Re: Structural Observation — 7232 Elliot Bridge Road, Spring Lake NC 28390

Floor Framing Reinforcement

Tar Heel Basement Systems
7232 Elliot Bridge Road
Sanford, NC 28390

Picture 2 – Area of creaking floors in the primary bedroom

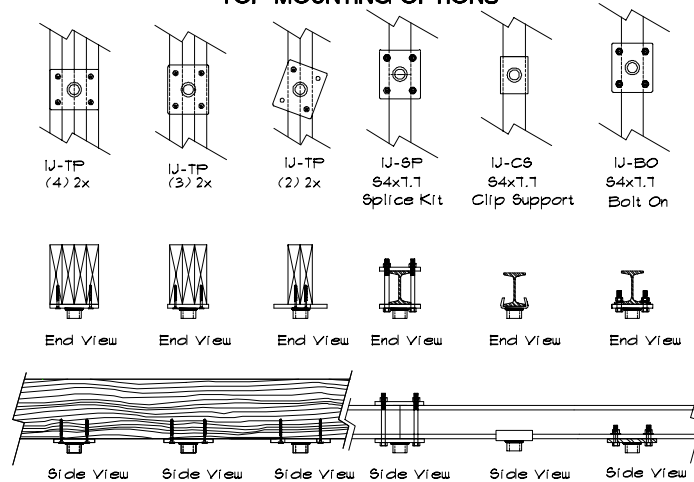
- Creaking floors were noted in the primary bedroom (*see picture 2*) and living room (*see picture 3*).
 - Measurement by laser level indicated that the back girder line was down as much as approximately $\frac{1}{2}$ " and $\frac{3}{4}$ " relative to the front girder line and back foundation wall, respectively.
 - Additional measurements indicated that the joists in the middle joist bay were sagging by as much as approximately $\frac{1}{2}$ " at mid-span.

- 1) To reinforce the living room and bedroom floor framing, install a supplemental S4x7.7 dropped girder within the middle $\frac{1}{3}$ of the joists. The new girders should span from the locations shown in the attached repair schematic over IntelliJack supports on well-compacted 18"x18"x18" gravel footings spaced no more than 6'-0" apart.
 - a) The ends of the girder may cantilever up to 2'-0" over the ends of the support.
 - b) If the creaking floors are caused by missed subfloor fasteners, further engineering may be required to reinforce the subfloor.
